*Technical Memo 2016-1115
November 2016*

Evaluation for Unreasonable Impacts: Needmore Water, LLC, Well D Permit Application

Brian B. Hunt, P.G., and Brian A. Smith, Ph.D., P.G.

Figure 1. Graphical presentation of drawdown versus time from the Needmore pumping alone at the Amos observation well (assuming Table 1 parameters). Note most of the drawdown occurs within the first year.

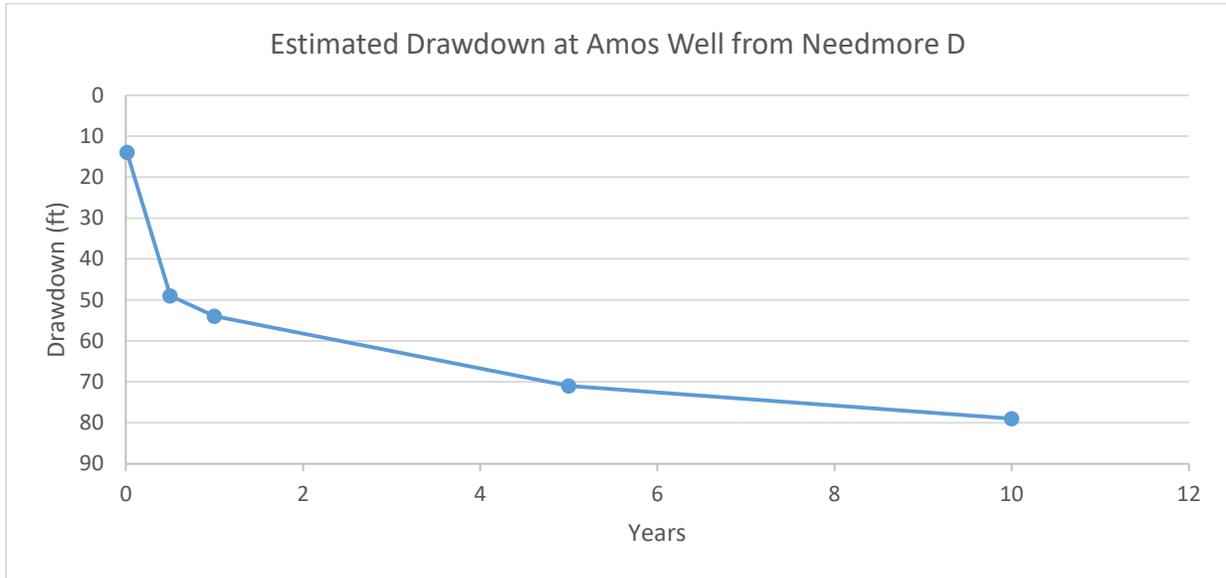
Using the aquifer parameters derived from the aquifer test (**Table 1; Appendix A**), the AS staff estimates the additional drawdown from the Needmore pumping over time in **Figure 1**. For the evaluation, AS staff chose drawdown from pumping over a seven-year period. This period was chosen to be representative of a severe drought when little recharge occurs and capture is constrained. The results of the estimated drawdown at the Amos Well due to Needmore pumping is about 75 ft after seven years (**Figure 1**).

Figure 2. Potential Index Well Diagram and Compliance Levels

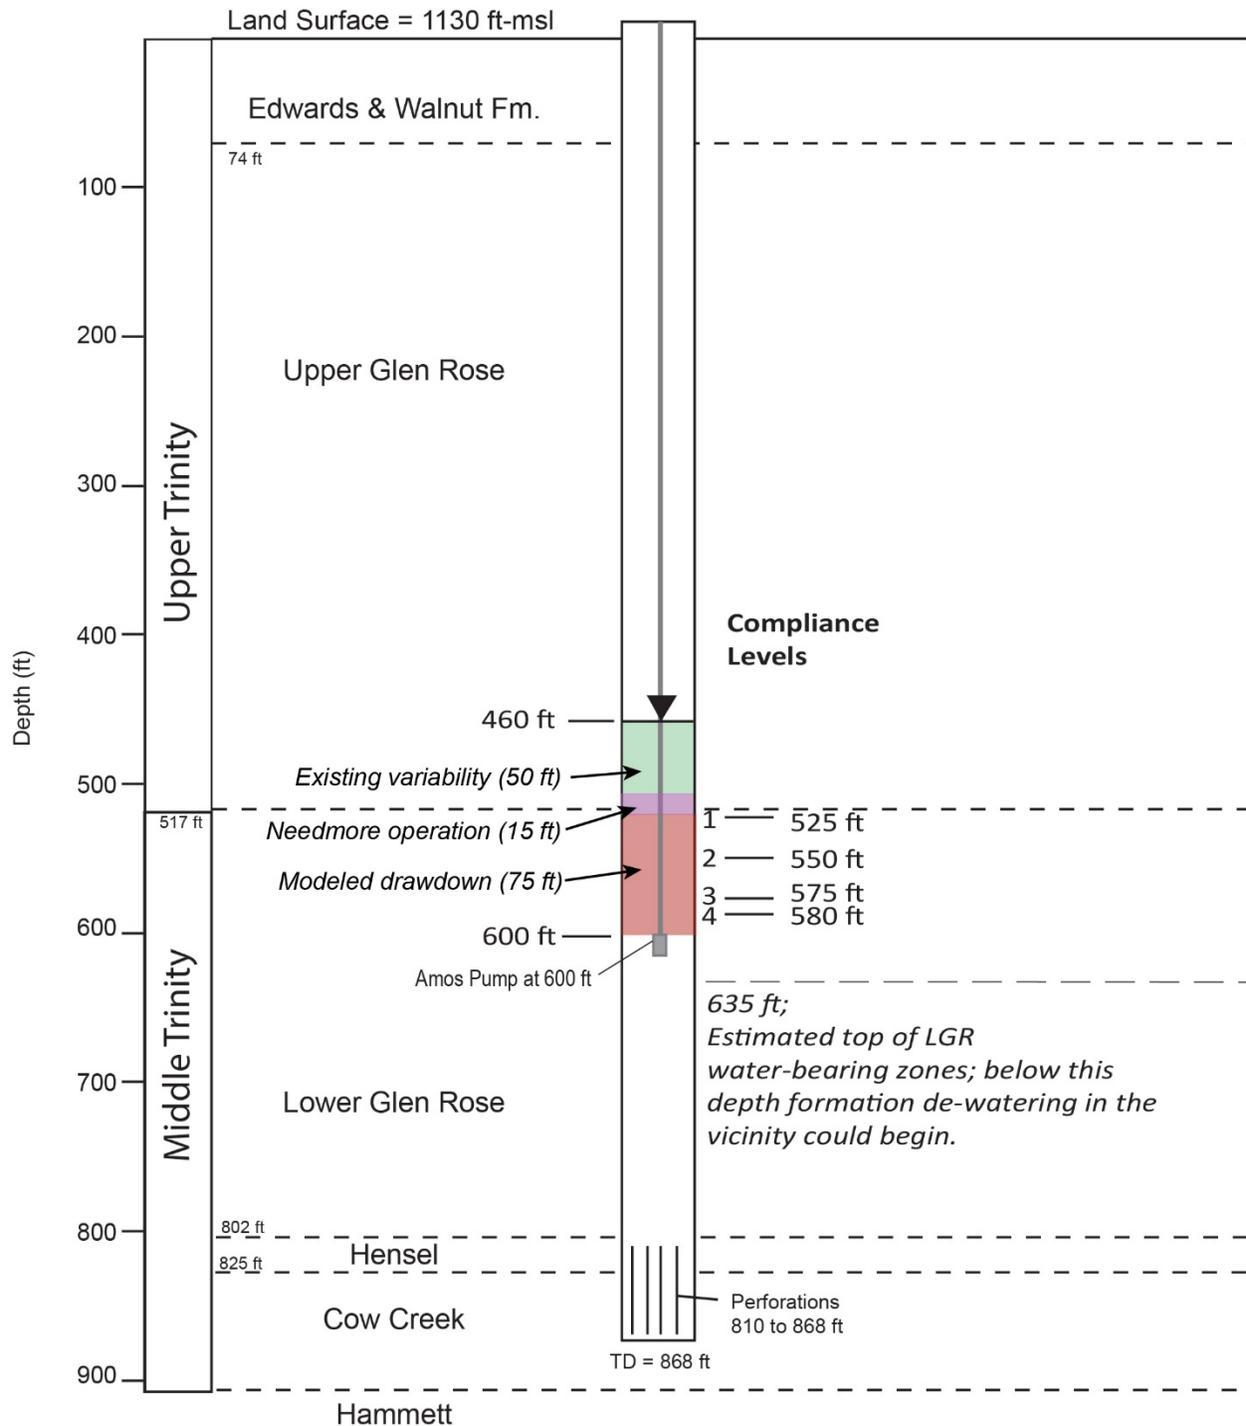
Table 3 presents a summary of the specific compliance levels derived for the Amos Well. **Figure 2** is a graphical representation of the Amos Index Well and the corresponding compliance levels. Compliance levels were set after considering natural water-level variability (Table 2; 50 ft) and also the observed short-term operational effects of pumping from the Needmore Well (~15 ft). Thus, this allows for up to about 65 ft of variability below the average water level before crossing the first compliance level threshold. **Figure 3** is a conceptual diagram showing how each compliance level is distributed over depth and time.

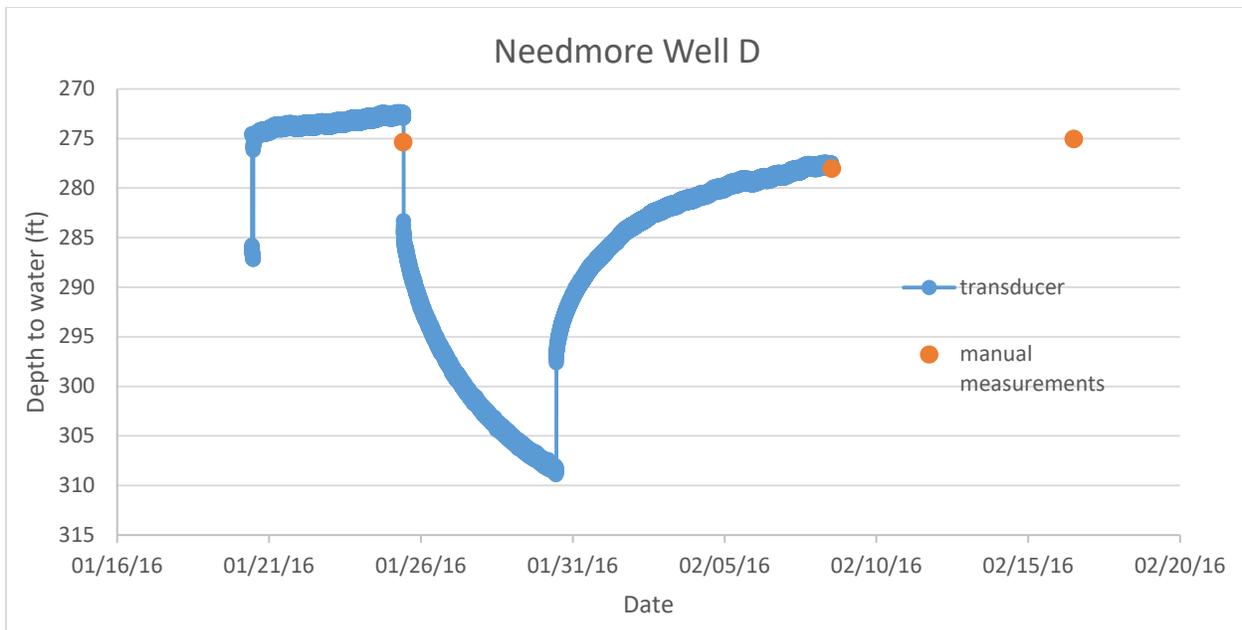
Figure A-3. Hydrograph of the Needmore D pumping well transducer and manual data. Water levels were rising from pre-test of pump on 1/20/16 when the test started on 1/25/16. Note that a “pumping level” or psuedo-steady state was not reached before the end of the pumping phase. Maximum drawdown was 35 feet at the end of the test. Water levels reached 86% recovery after 14 days when the transducer was taken out, and 94% after 22 days of recovery. The last measurement was on 2/16/16.

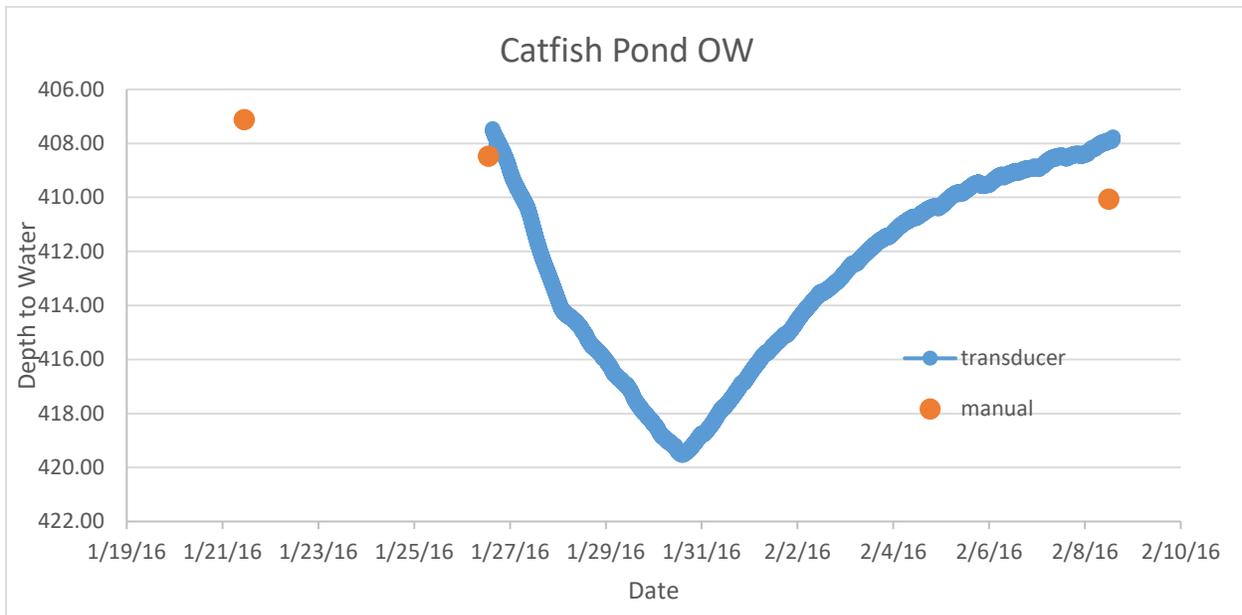
Figure A-4. Hydrograph of the Catfish Observation Well transducer and manual data. An error in the placement of the transducer resulted in missing early-time data. Note that there is 0.7 ft discrepancy in the manual measurements and the transducer data on 1/26/16. There is about a 2.0 ft discrepancy in the manual measurements and transducer data on 2/8/16. Source of the error is unknown, but it could

be double subtractions of a measurement point. Maximum drawdown during the test was 16 feet. Water levels reached 90% recovery after 13 days. The last measurement was on 2/8/16.

Figure A-6. Hydrograph of the Top of the Hill Observation Well transducer and manual data. Note there is 0.7 ft discrepancy in the manual measurement and the transducer data on 2/8/16. Source could

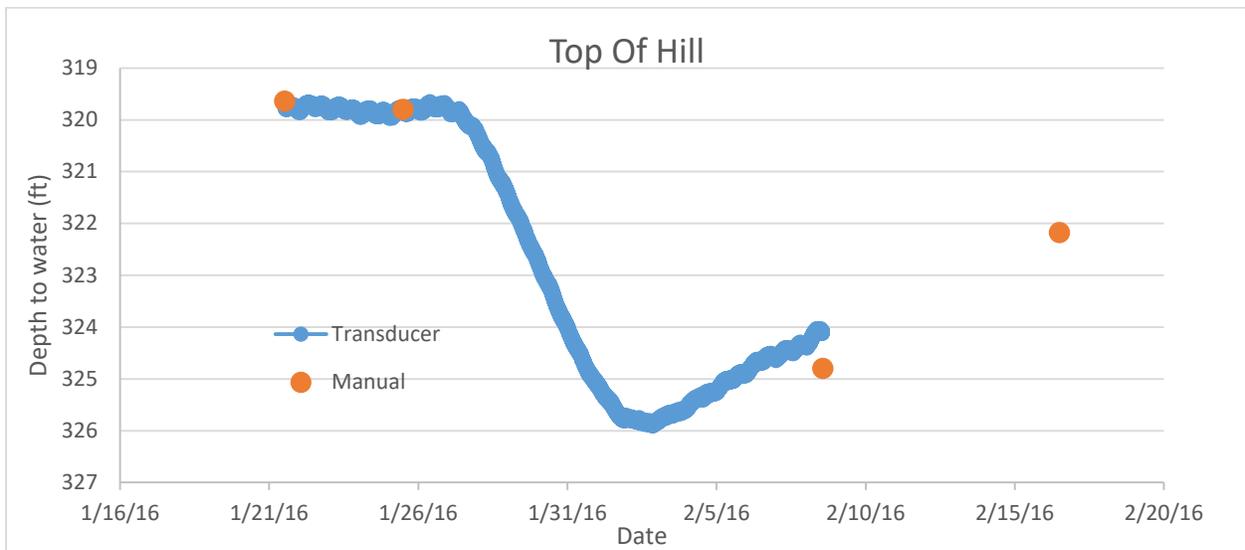
be instrument drift or manual measurement error. Pre-test water level trends are relatively flat. Maximum drawdown was about 6 feet. Water levels reached 60% recovery after 22 days. The last measurement was on 2/16/16.
